NOVEMBER 2019

PL6

NON MATERIAL
AMENDMENT
PLANNING
APPLICATION
& CONDITION 4
DISCHARGE

44 A GLOUCESTER
AVENUE LONDON
NW1 8JD

2.4 CHANGES TO CONSENTED DEMOLITION FRONT ELEVATION

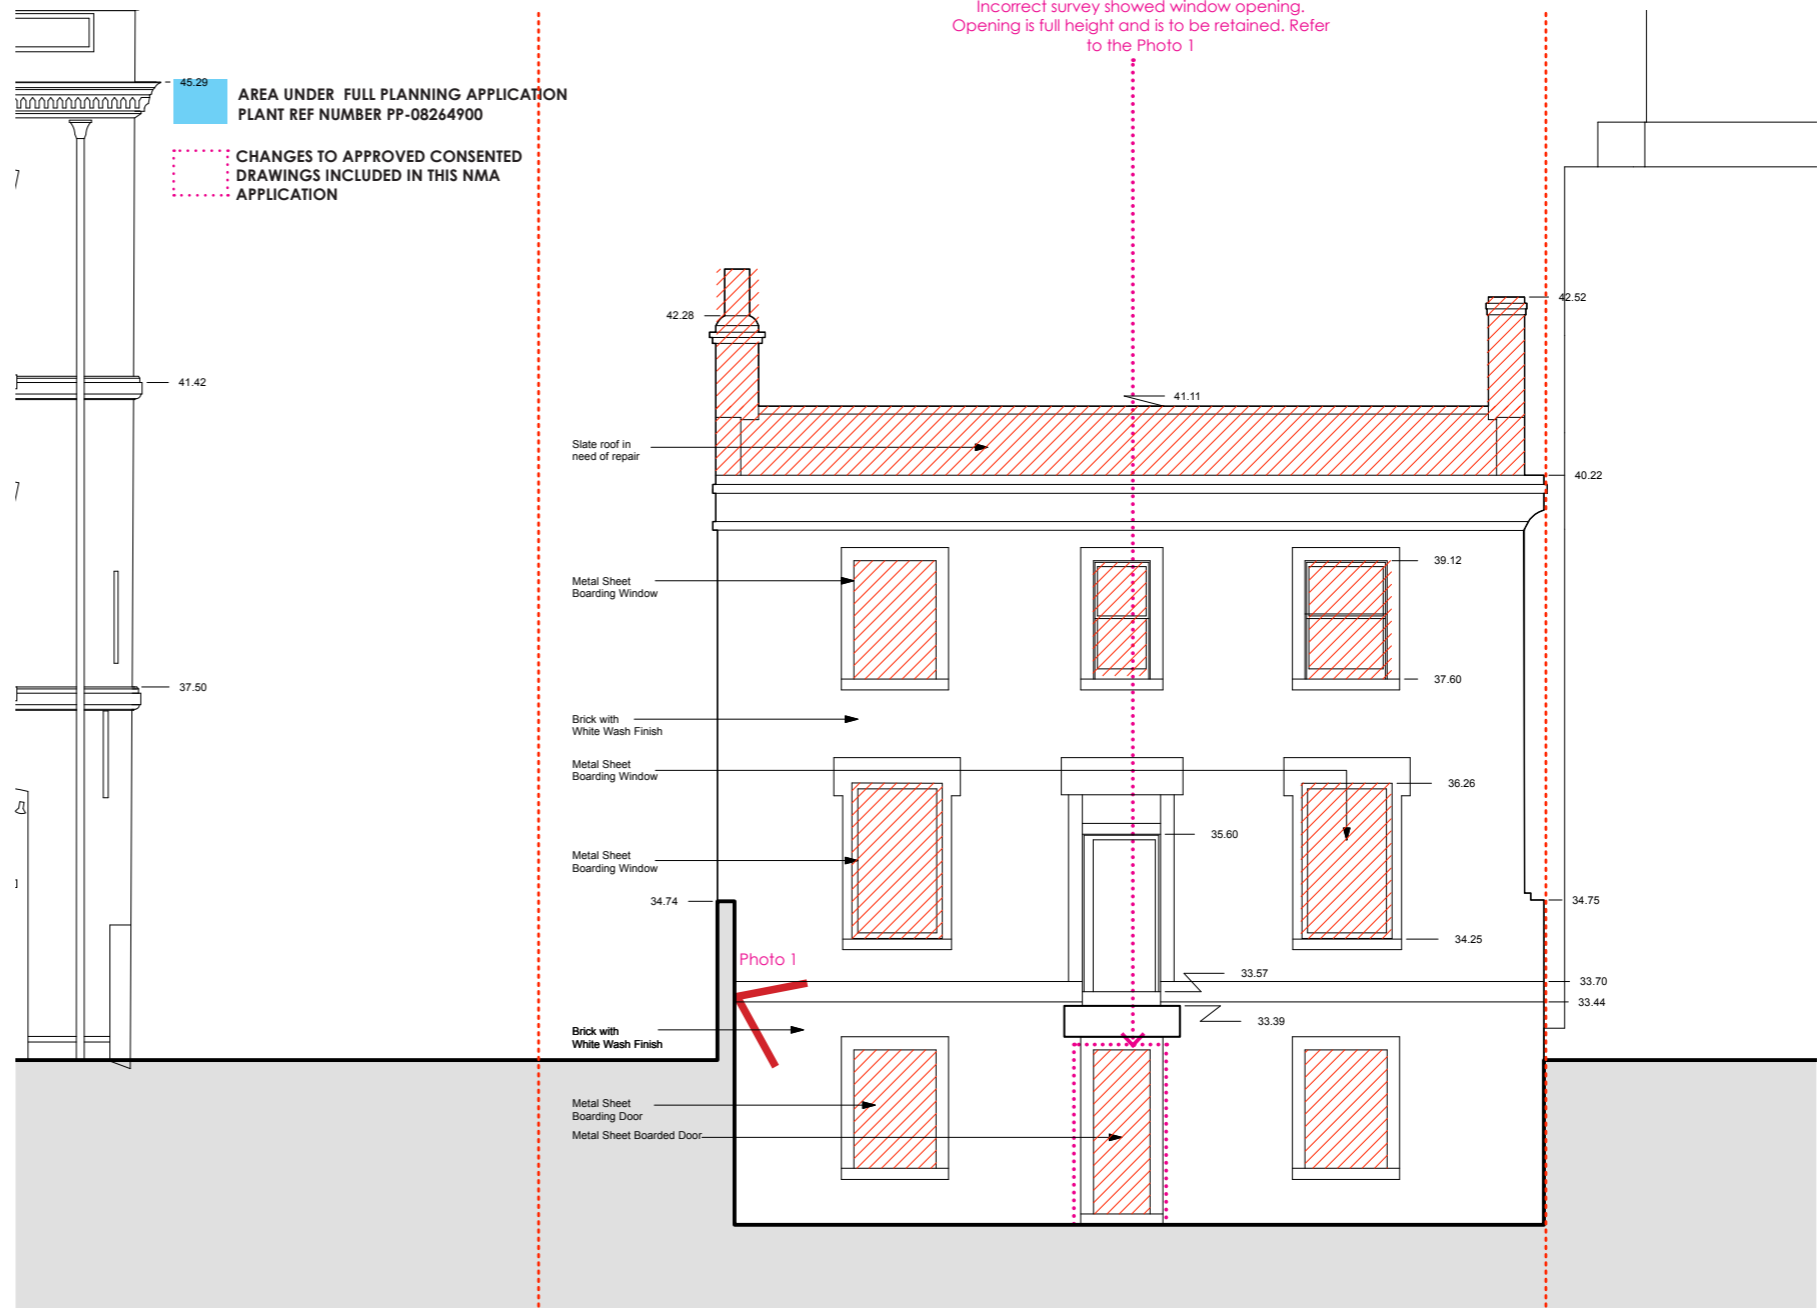
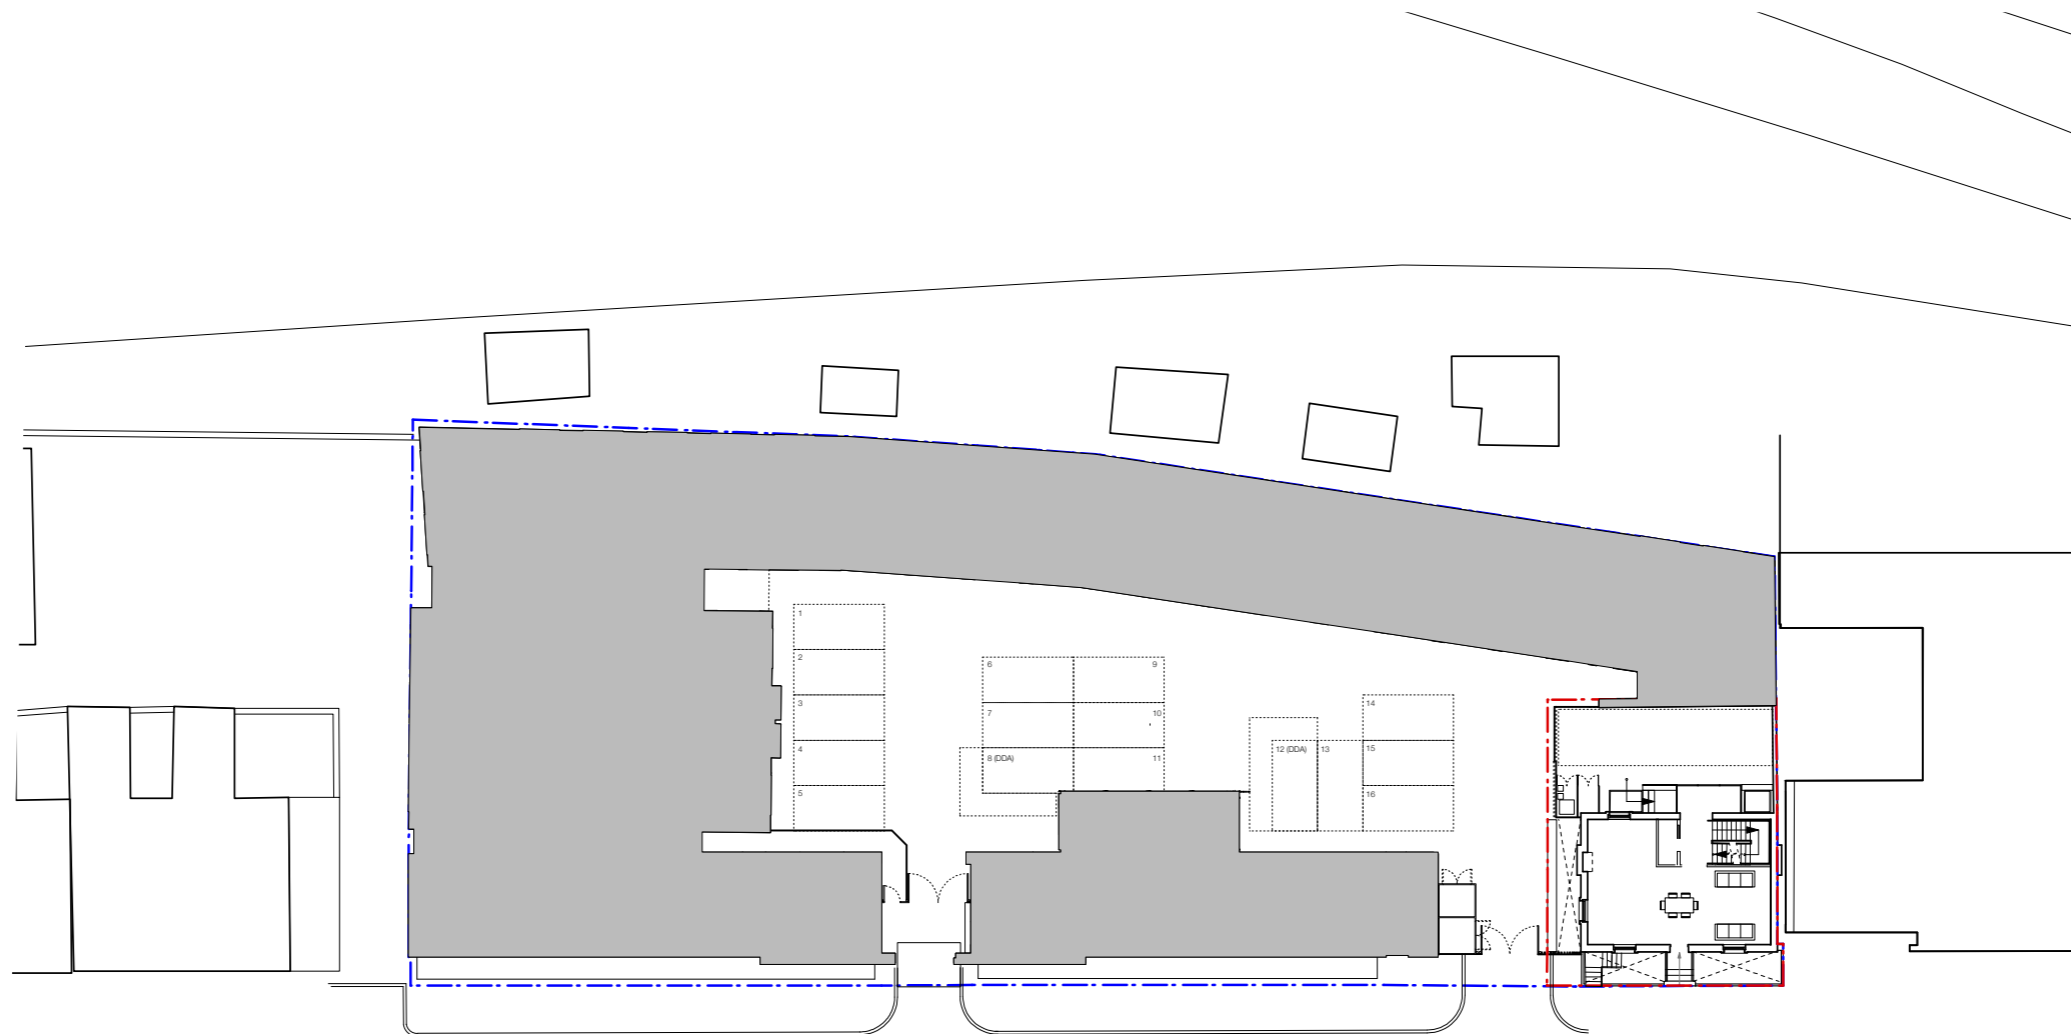
PHOTO 1. PHOTO OF THE EXISTING FULL HEIGHT OPENING

2.5 CHANGES TO CONSENTED BLOCK PLAN

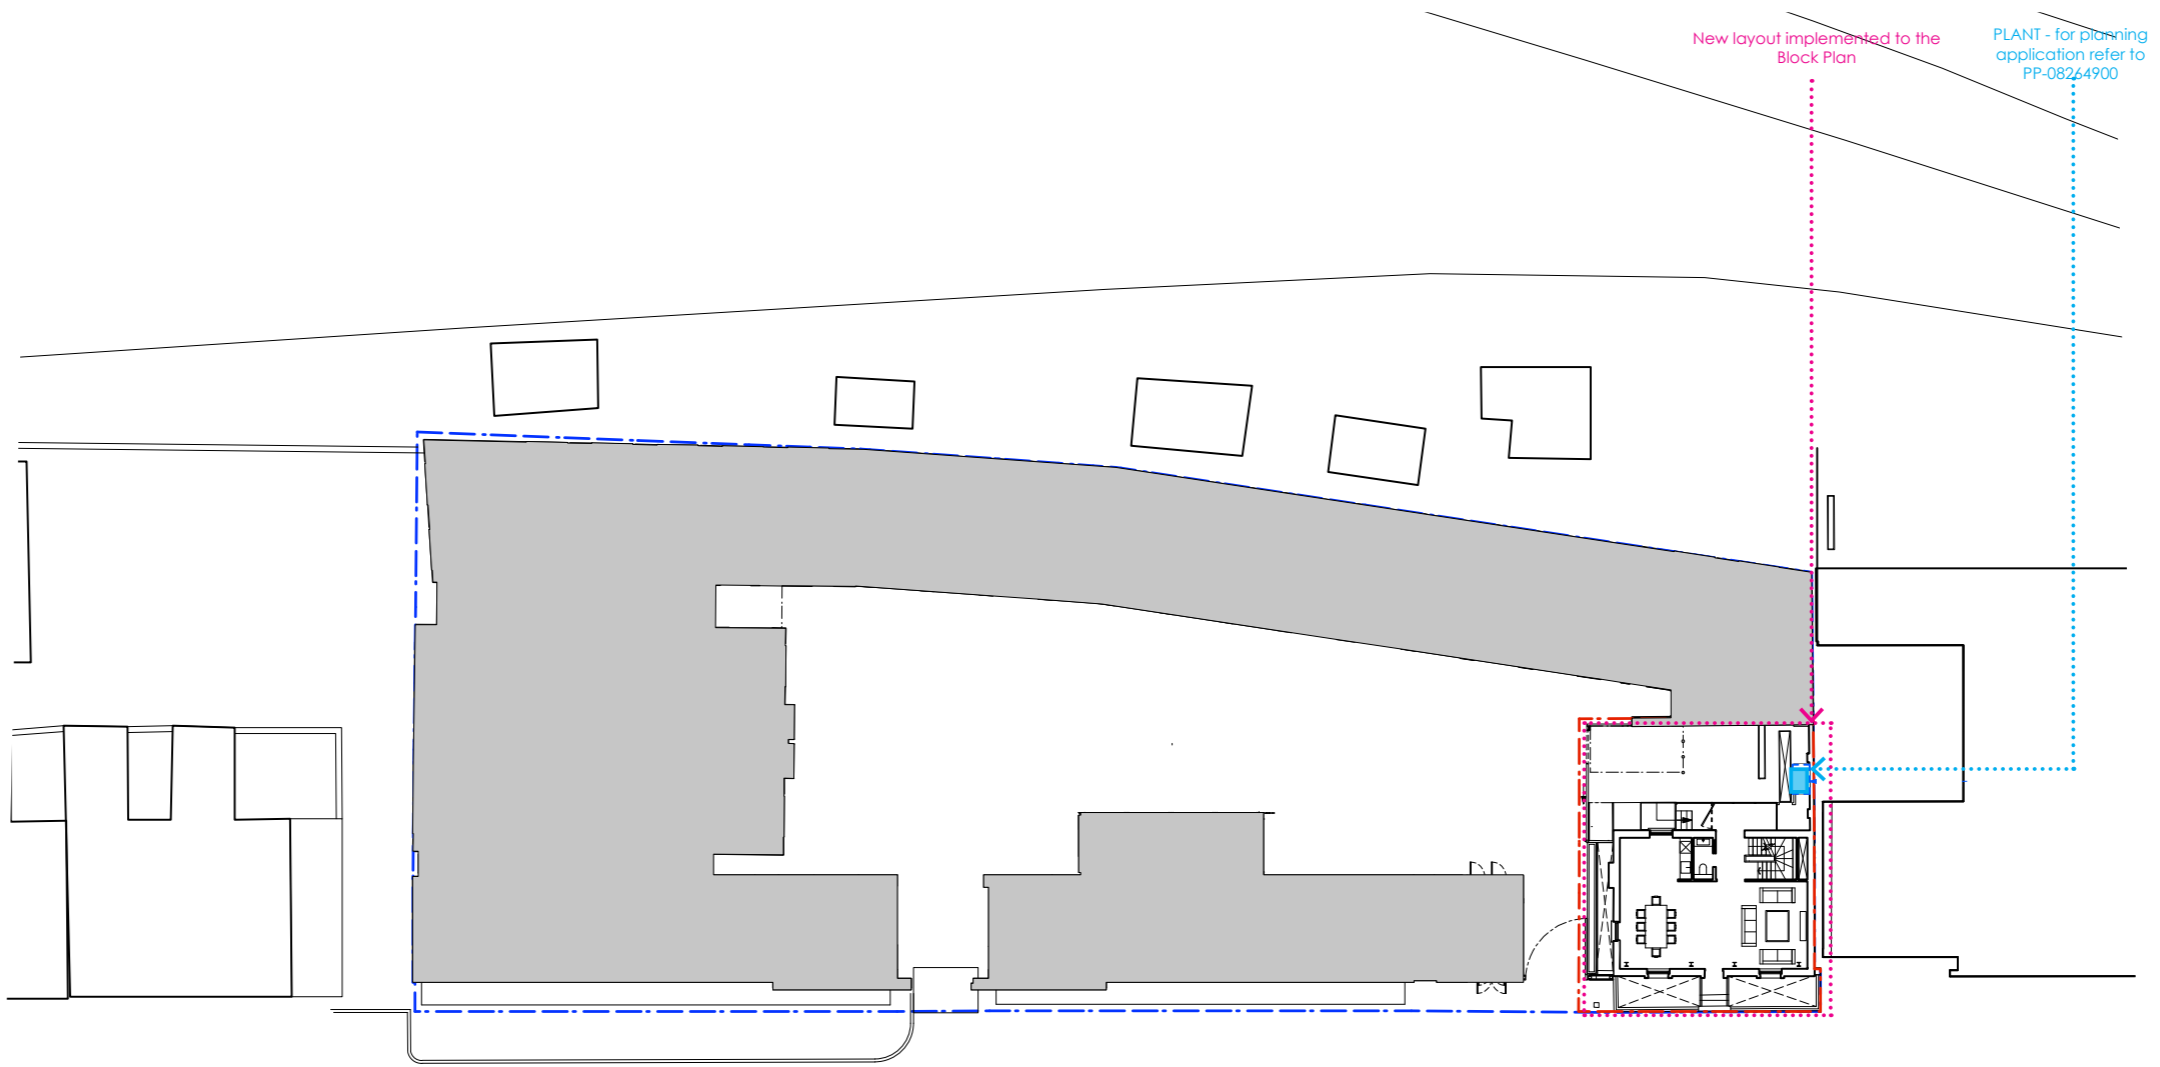
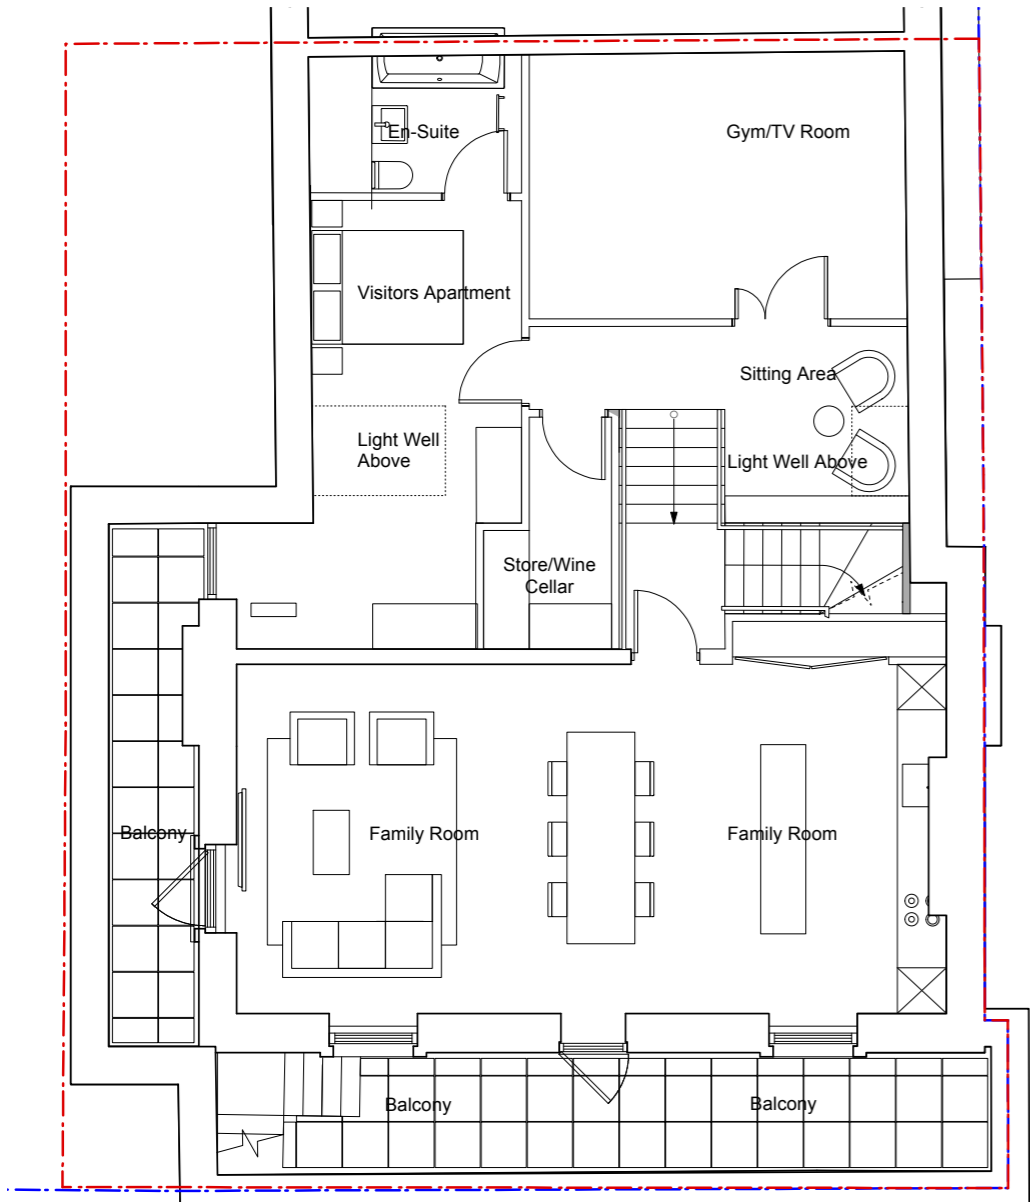
- Planters have been placed in the rear courtyard
 - Lightwell relocation and change in plan to adapt to new layout
 - Bollards have been added to the parking space to the rear courtyard. Specification for the pavers incorporated in the scheme

- 1.45 Planters have been placed in order to provide visual barrier to bin store. Existing approved store to be modified to cycle store.
- 1.46 Bollards to the car park have been added for safety measures
